Notice of Availability of NUREG-0654/FEMA-REP-1, Revision 1, Supplement 3, Guidance for Protective Action Recommendations for General Emergencies

**Subject:** NEI Comments on NRC Proposed Draft NUREG-0654 FEMA-REP-1, Revision 1, Supplement 3, "Guidance for Protective Action Recommendations for General Emergencies; Draft for Comment," *Federal Register (FR Vol. 75, No. 44)*, Docket ID NRC-2010-0080

**NEI COMMENTS ON Draft NUREG 0654 Supplement 3  
COMMENT AREA: Implementation Methodology**

PROTECTIVE ACTION RECOMMENDATION LOGIC DIAGRAM

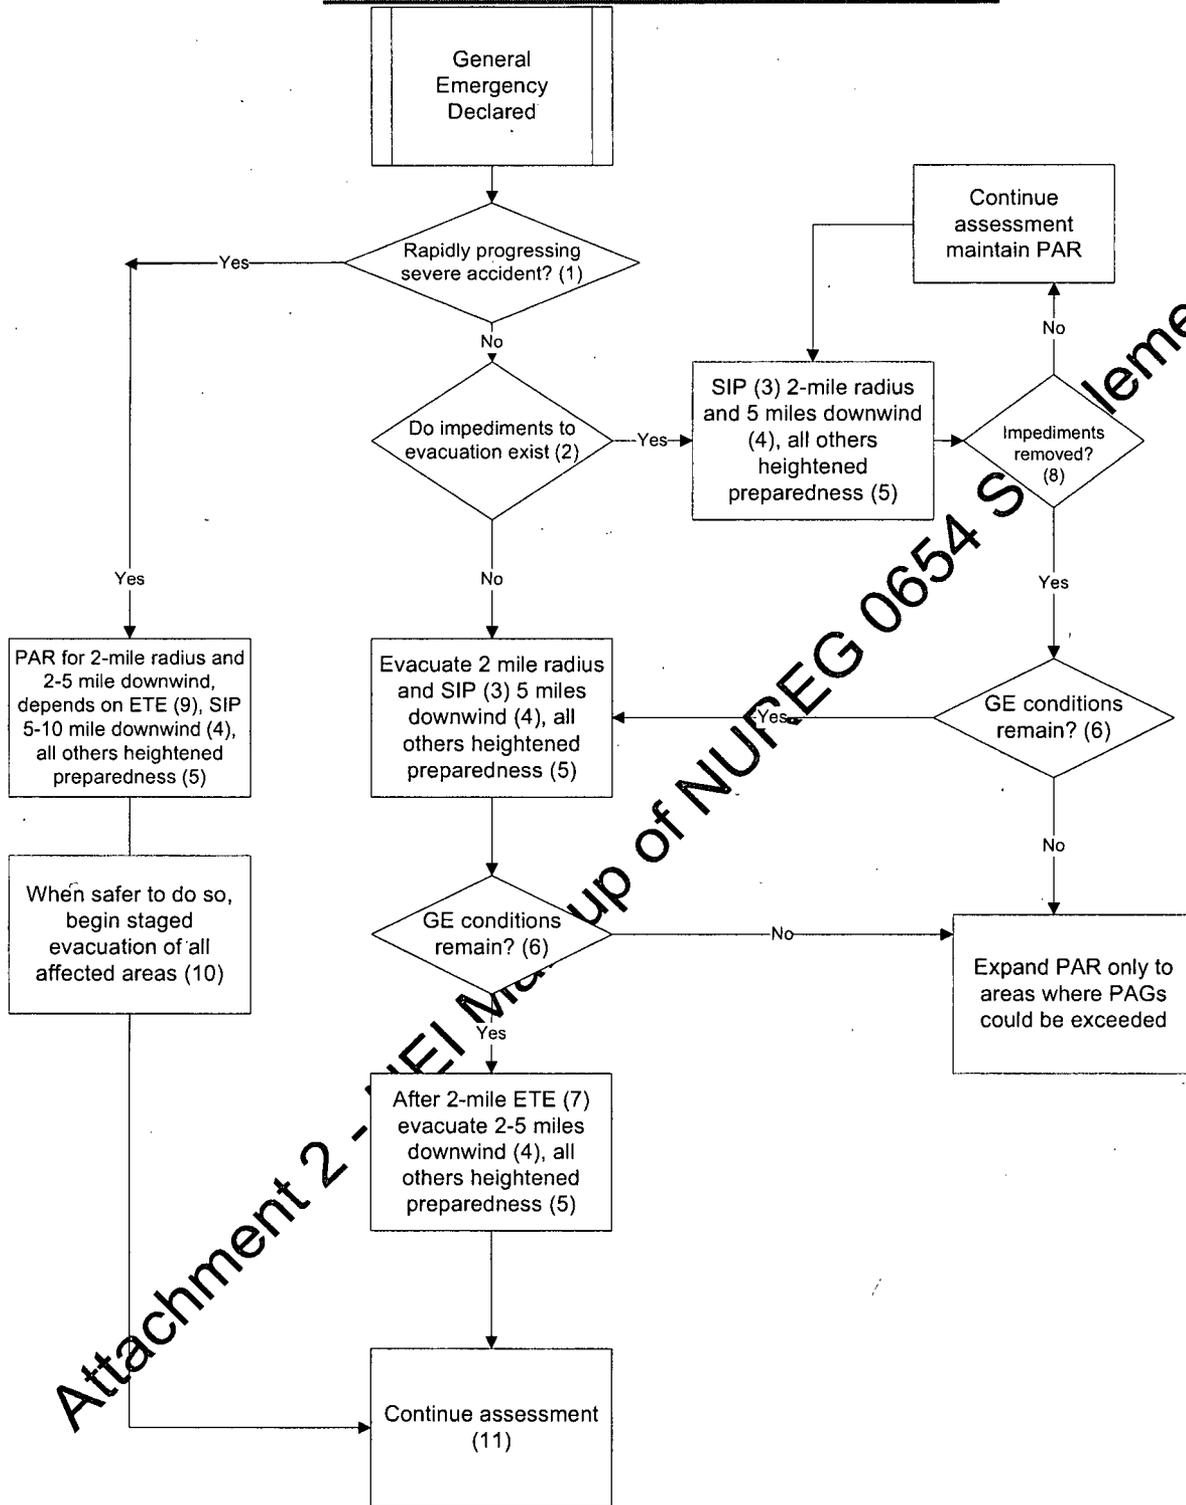
The logic diagram provided in the draft Supplement 3 does not provide consideration of all elements in described in the document (e.g., wind shifts) and does not provide for an alternate approach to staged evacuation in cases where staged evacuation may not be of measurable benefit to the affected population as determined by ORO decision makers. In Attachment 2 NEI provides two mark-ups of the Supplement 3 Logic Diagram and proposed revisions to the associated notes.

The first mark-up version of the Logic Diagram excludes the rapidly progressing severe accident. NEI does not believe that the rapidly progressing severe accident scenario should be included in the Supplement 3 Logic Diagram. Current reactor accident analysis studies indicate that this accident is not credible (refer to NEI comment # 2 below and NEI comment #28 on page 21 of this attachment). Should the NRC accept this comment, a proposed logic diagram (and notes) is provided with this element removed beginning on page 18A of Attachment 2.

**REPLACE WITH EITHER OPTION A (RAPIDLY PROGRESSING SEVERE ACCIDENT REMOVED) OR B**

OPTION A – RAPIDLY PROGRESSING SEVERE ACCIDENT REMOVED

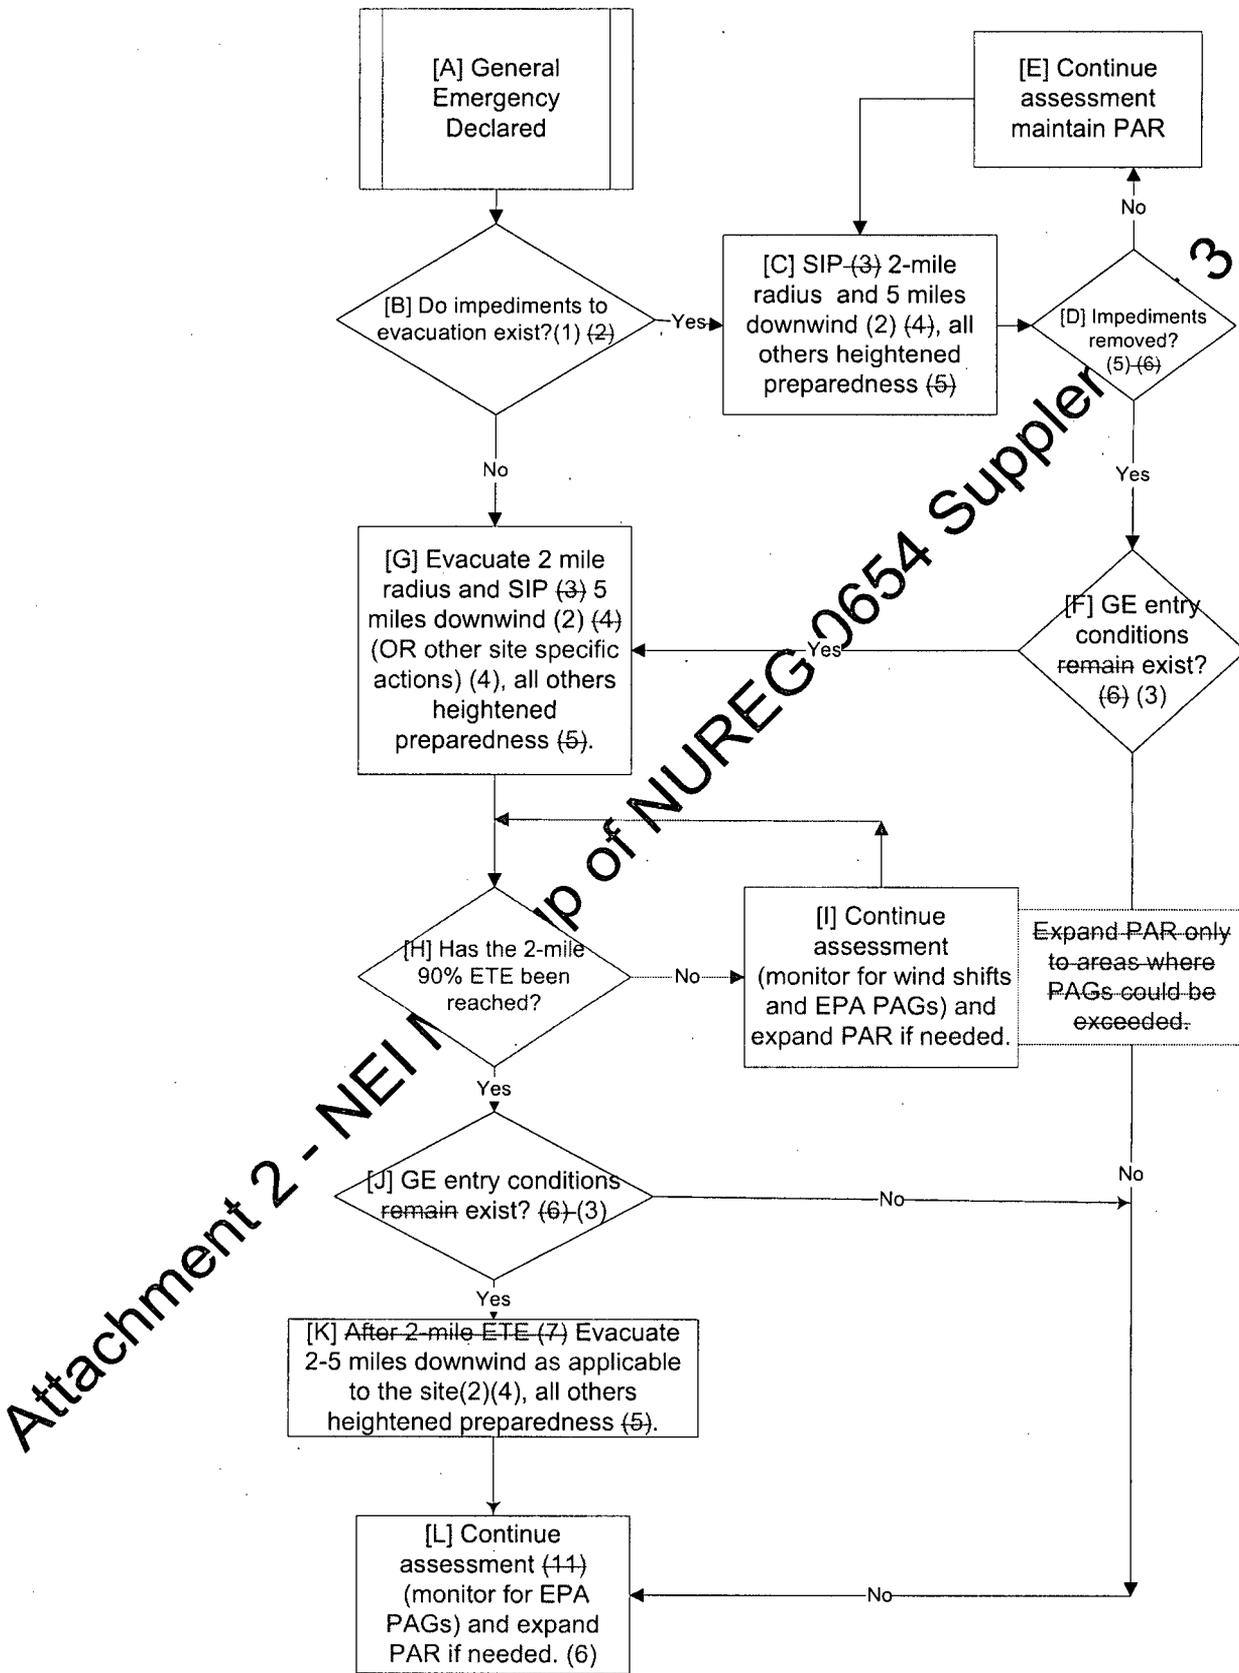
NEI provides a proposed revised version of this information in logic gates [F] and [J] on pages 18A and 18B and note 3 on page 20A (note 4 on page 20B) in the Supplement 3 mark-up contained in Attachment 2.

NEI provides logic diagram options on pages 18A and 18B in the Supplement 3 mark-up contained in Attachment 2 that address this comment (logic diagram blocks [I] and [L] and gate [H]).

OPTION B – INCLUDES RAPIDLY PROGRESSING SEVERE ACCIDENT

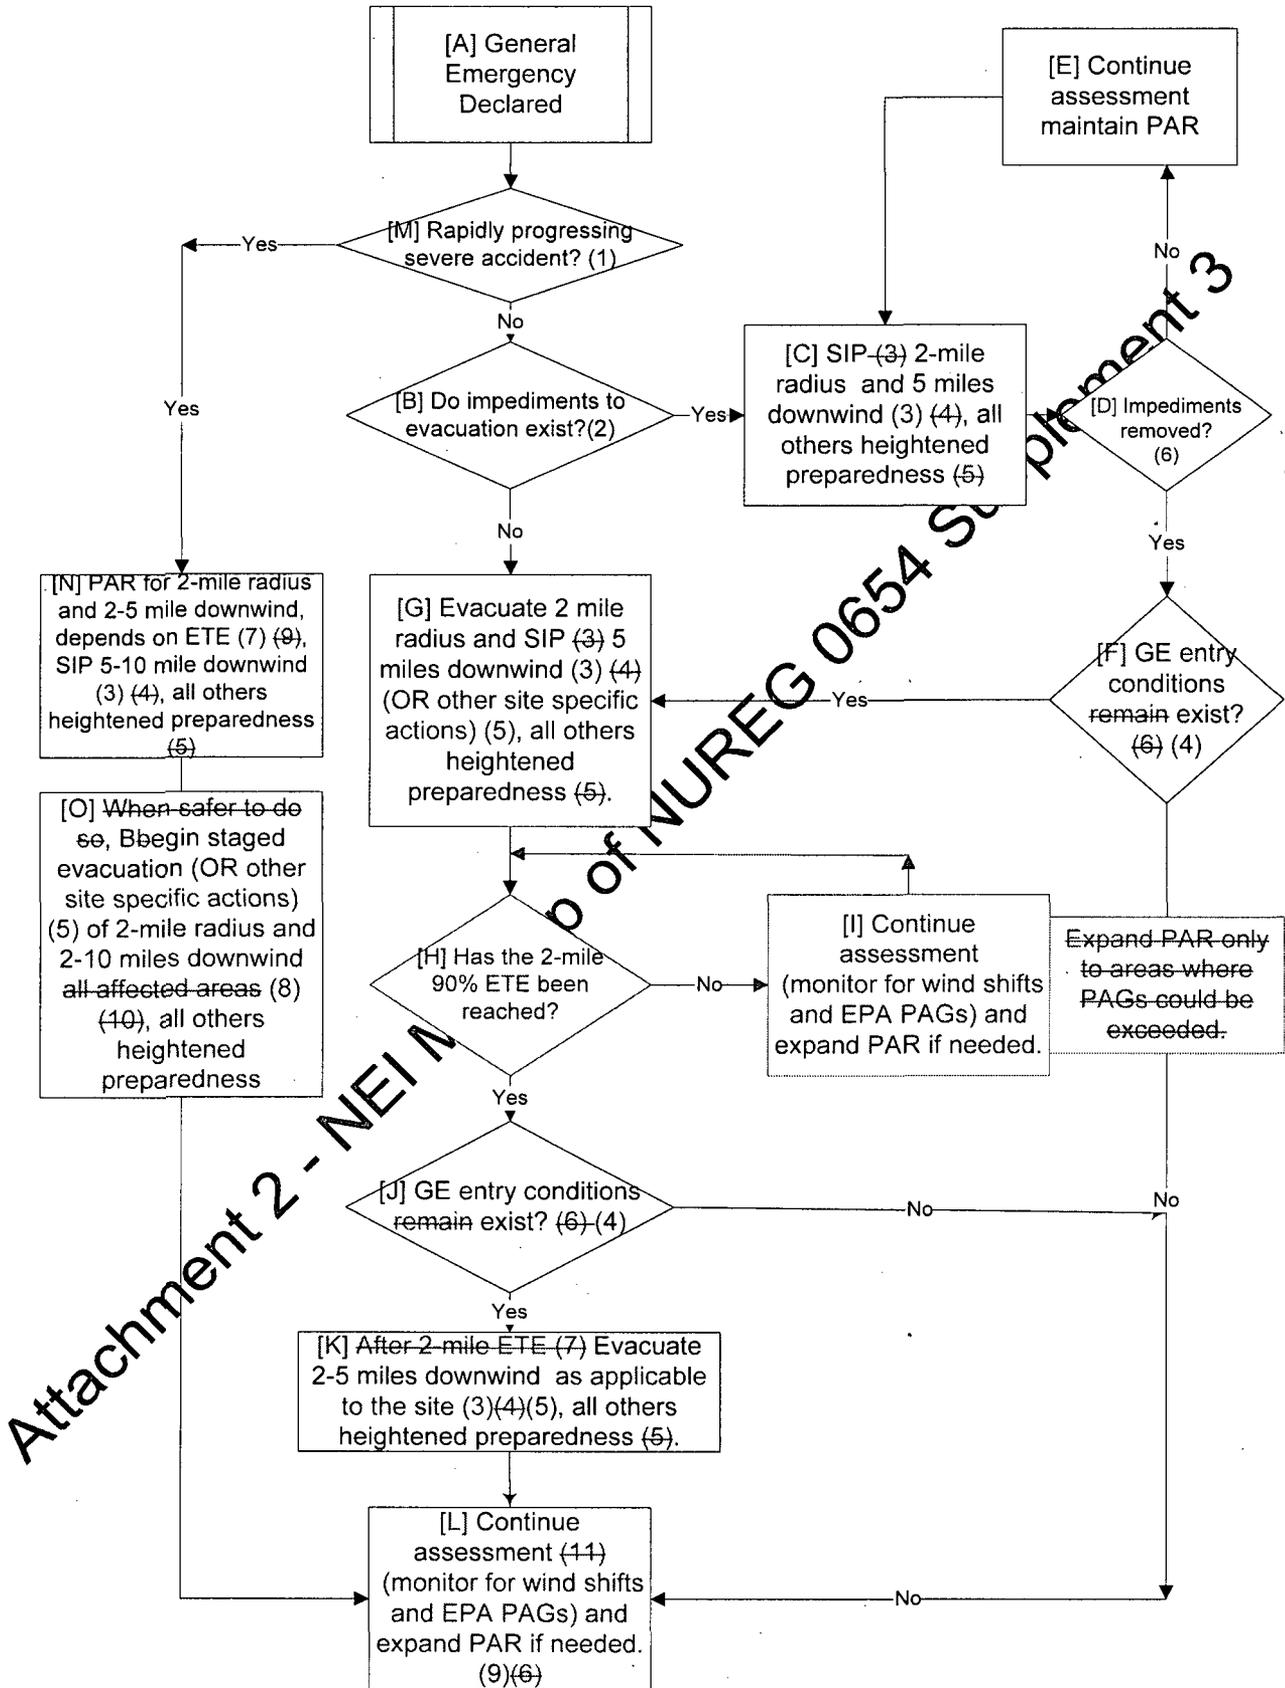
In the event that NRC does not agree to remove the rapidly progressing severe accident portion of the logic diagram, NEI is submitting a second mark-up of the proposed PAR Logic Diagram. The rapidly progressing severe accident portion of the PAR Logic Diagram is not usable as presented in the Supplement. A basis for this mark-up is provided in Attachment 1, NEI Comment #13.

NEI provides a proposed revised version of the information pertaining to rapidly progressing severe accident PARs in the logic diagram on page 18B and in notes 7 and 8 on pages 21B and 22B of the Supplement 3 mark-up contained in Attachment 2.
